## SOUTH SAN FRANCISCO UNIFIED SCHOOL DISTRICT

### **BID ADDENDUM NO. 1**

**PROJECT:** SSFUSD Alta Loma MS: Partial Storm Drain Replacement  
**DATE:** October 24, 2025

1: Excerpt of 1998 Landscape Project with current photos and notes

sheet no.  
L2.1

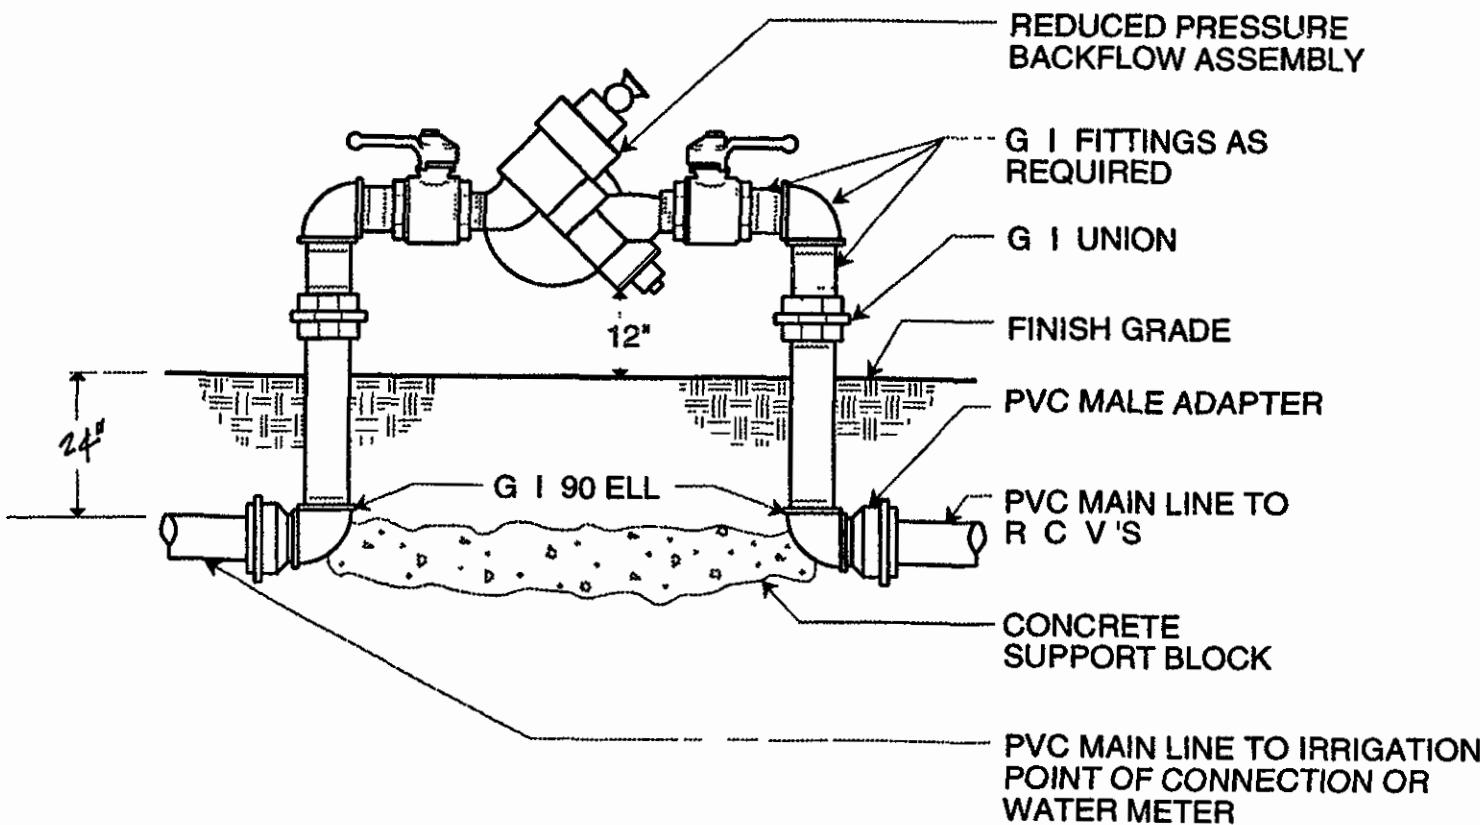
Bidders are required to include a utility locator service company to identify possible conflicts with Landscape irrigation lines at the general location shown in the attached drawings. Note that the proposed new line will run laterally from asphalt yard through dirt, and when it takes an angled path towards the CB-10, some conflict is anticipated that needs to be avoided.

Utility locating  
required
